JACKSON STREET SIDEWALK IMPROVEMENTS – PERRYMAN TO MILLER

Addendum No. 01

ADDENDUM 01

RIGHT OF WAY PLAN

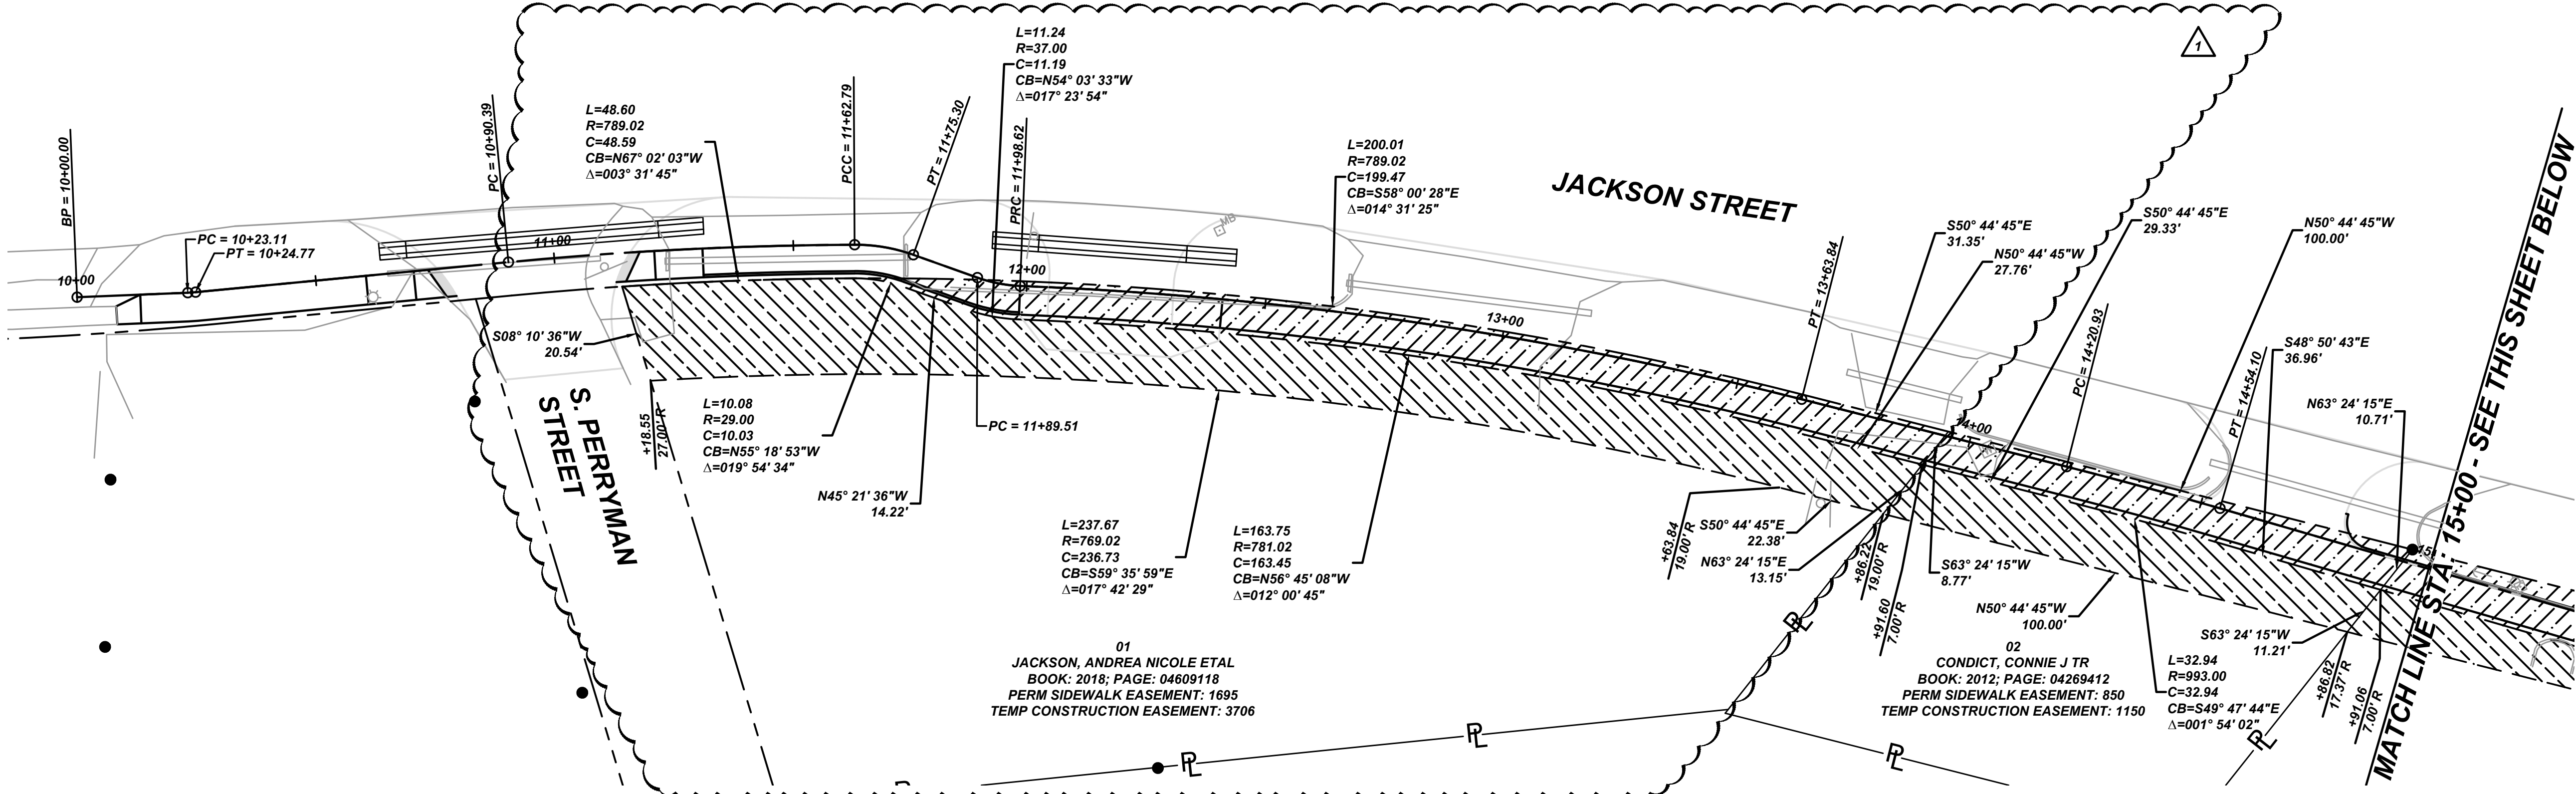
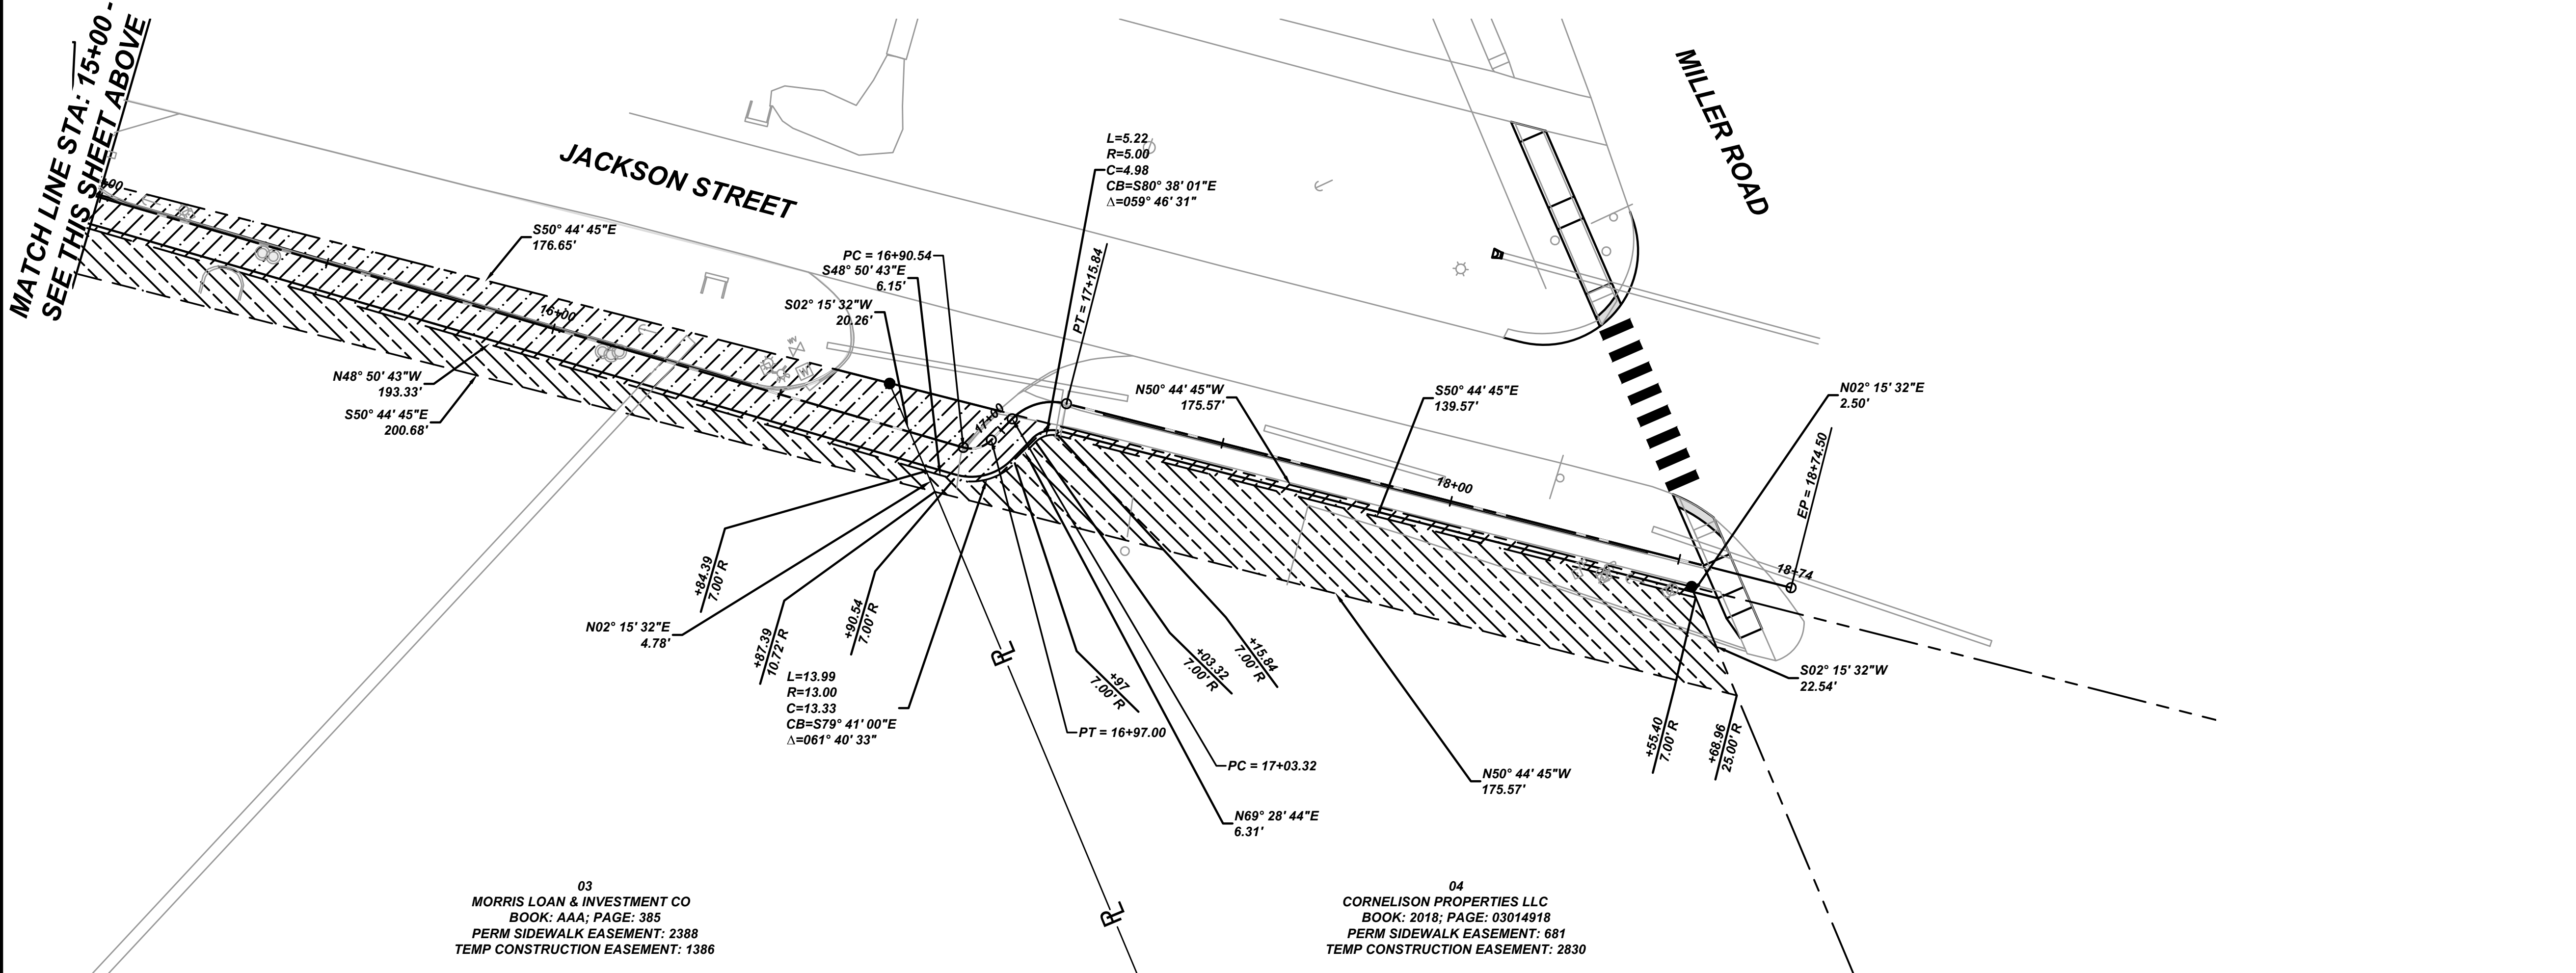
SHEET 05: The Easements on Parcel 01 have been revised for the relocation of Driveway 01

SIDEWALK PLAN & PROFILE

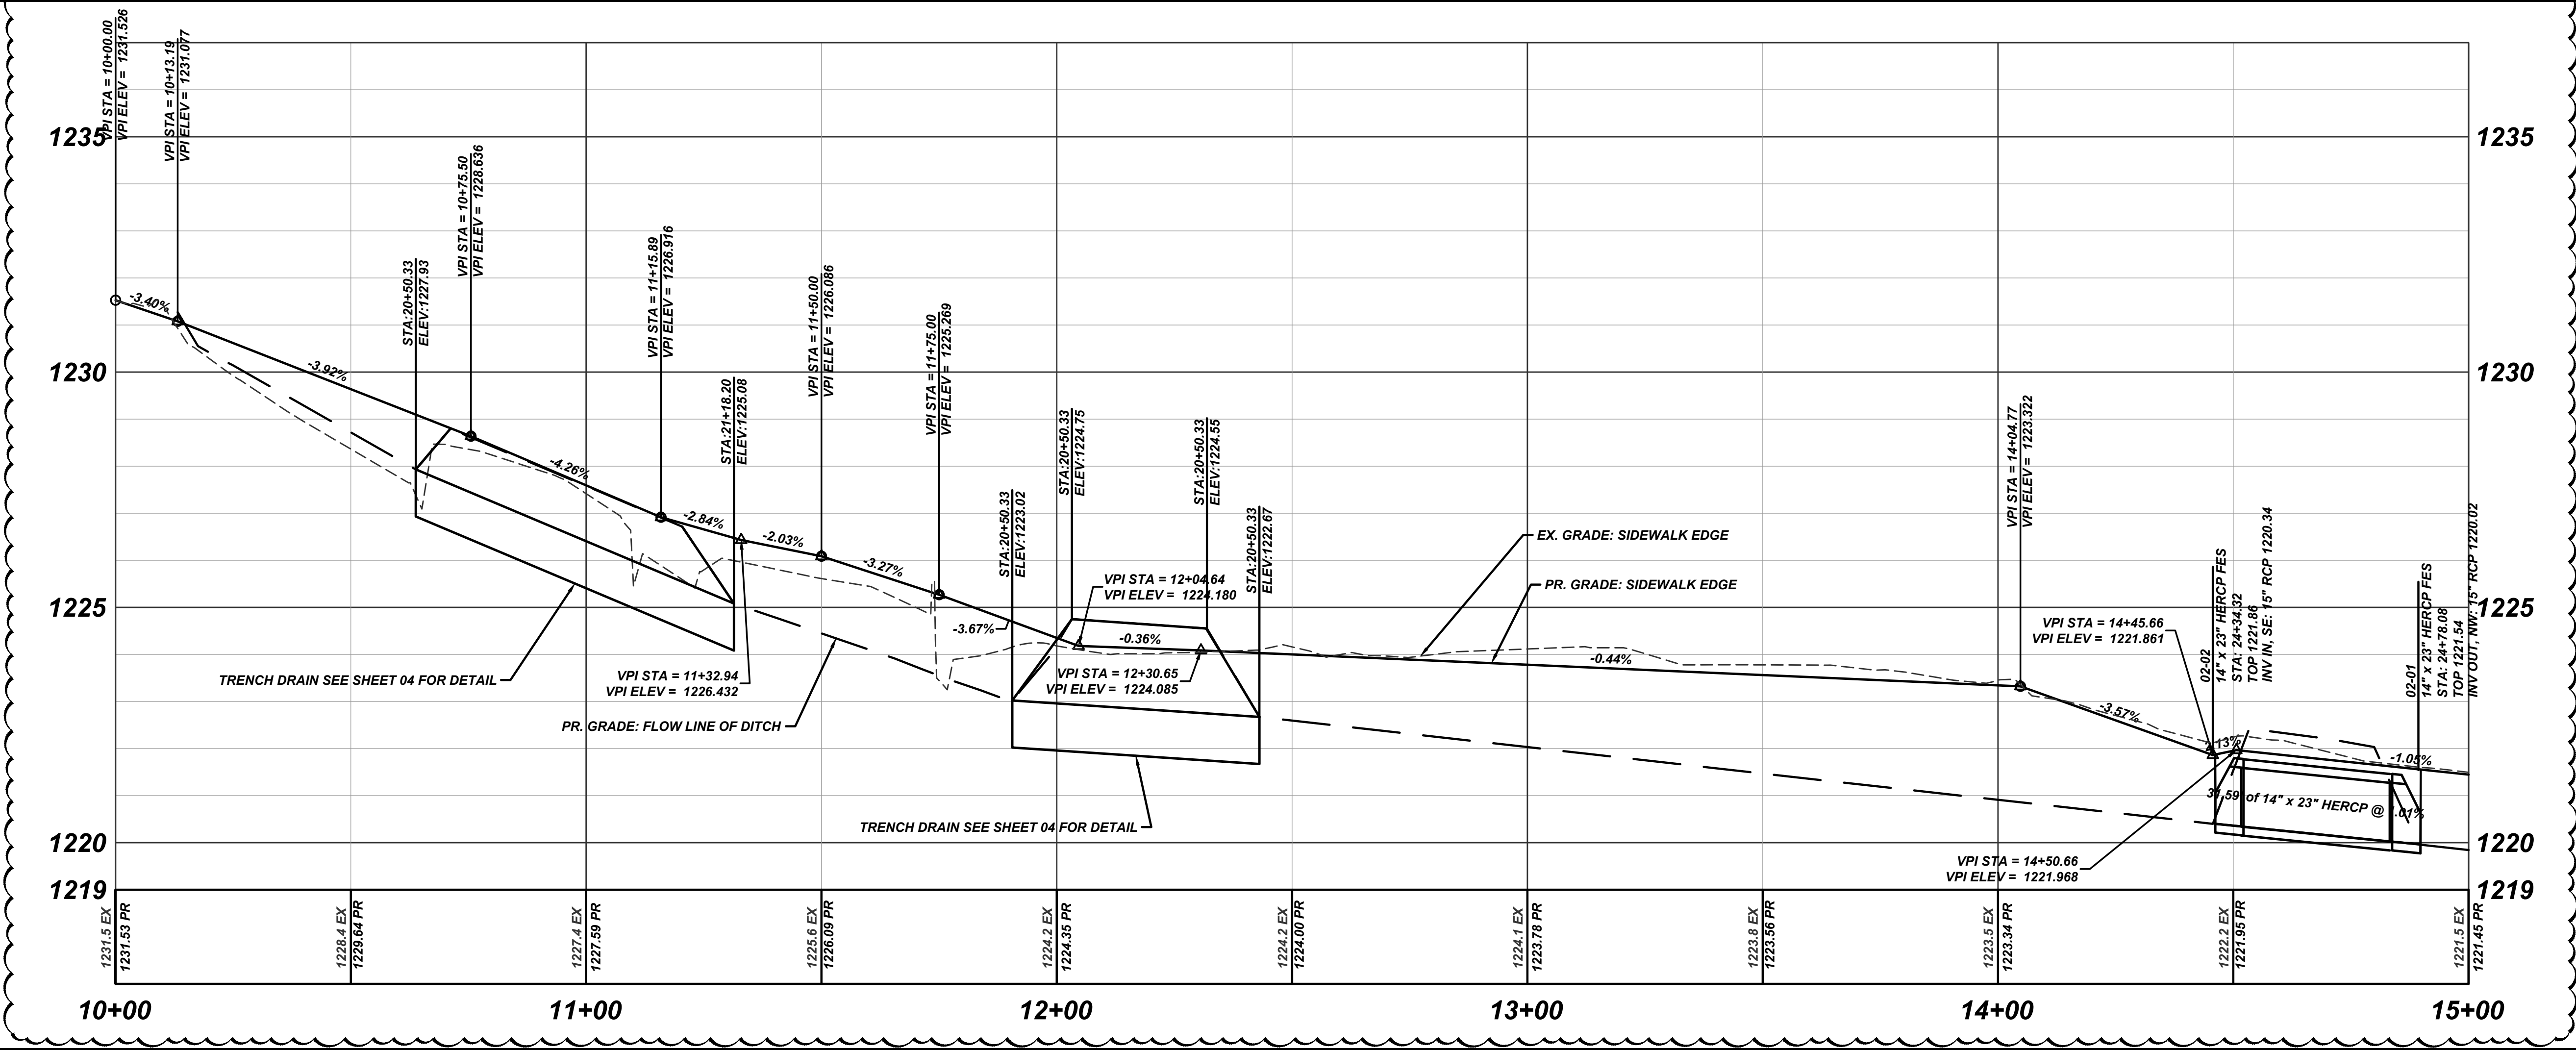
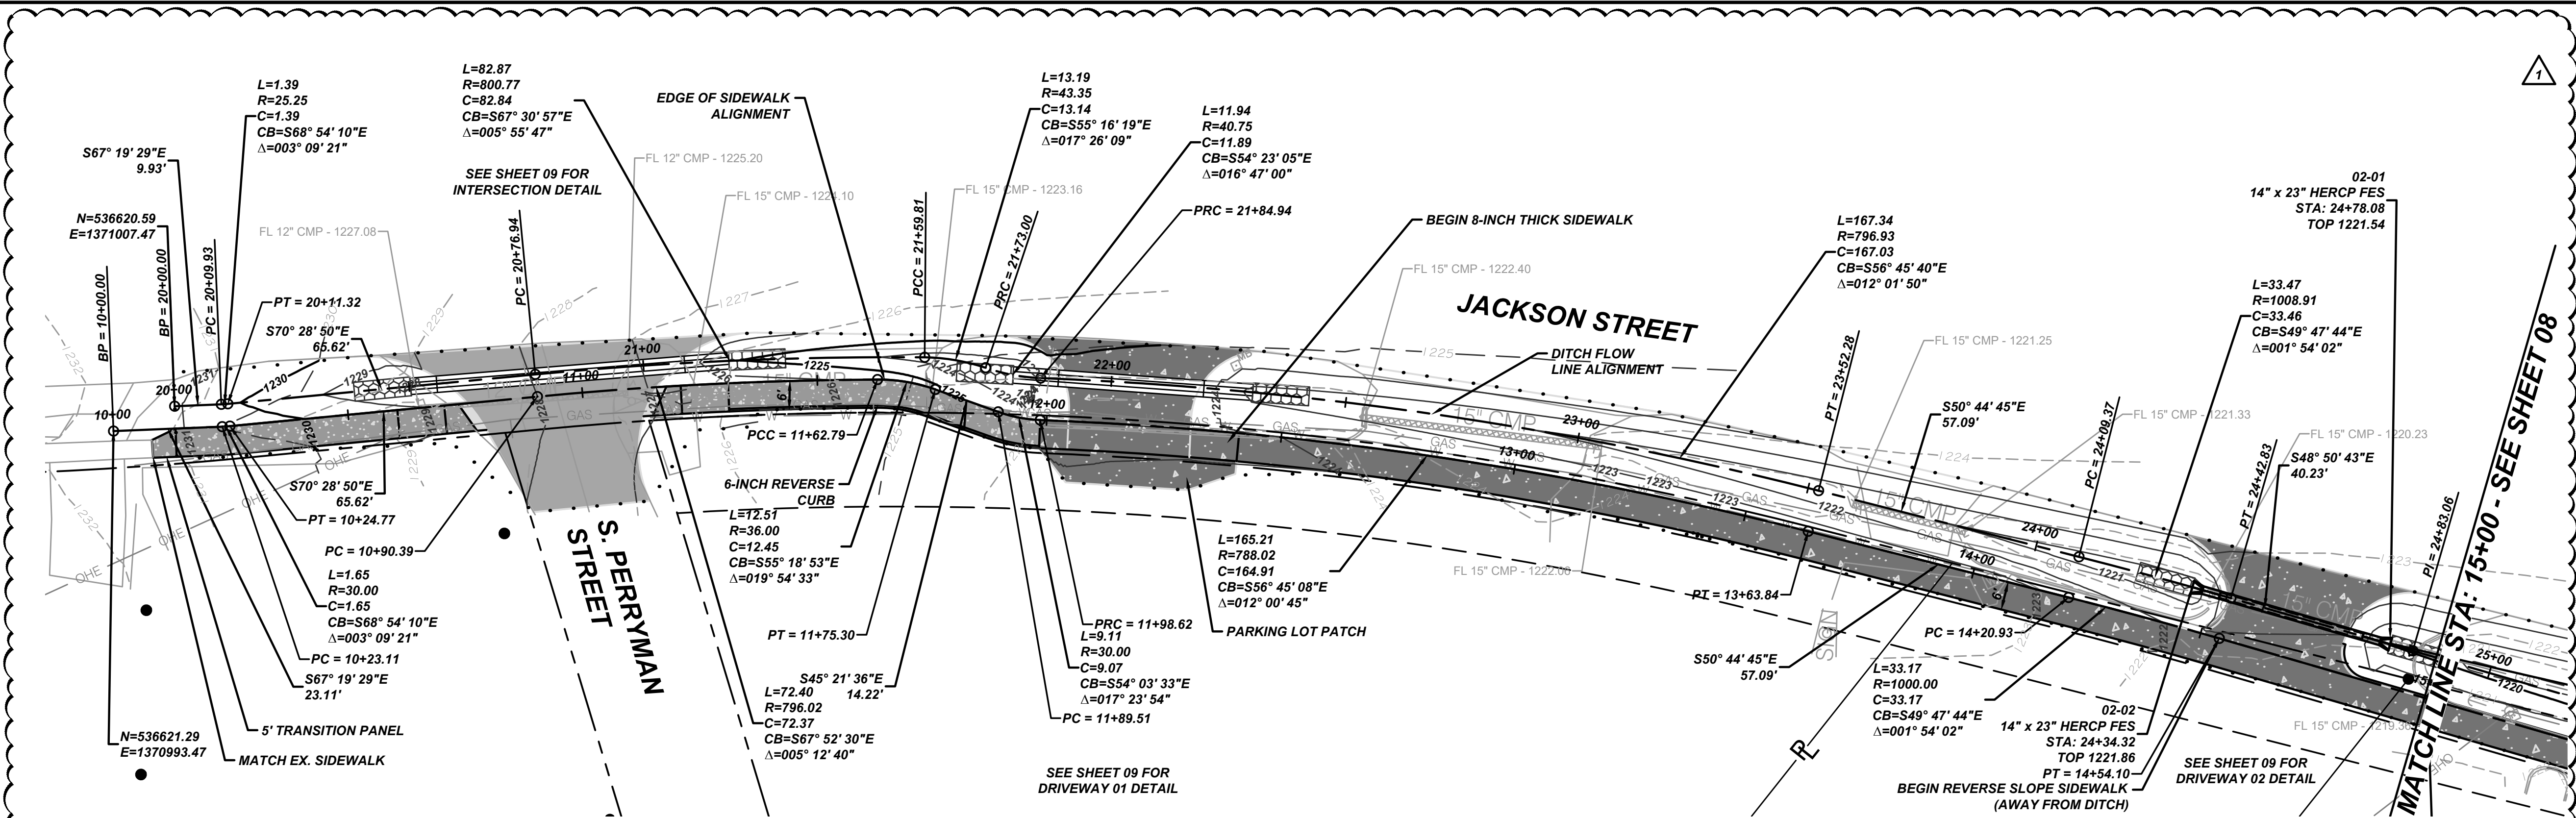
SHEET 07: The Plans have been revised to show the relocation of Driveway 01. This change increased the footage of trench drain.
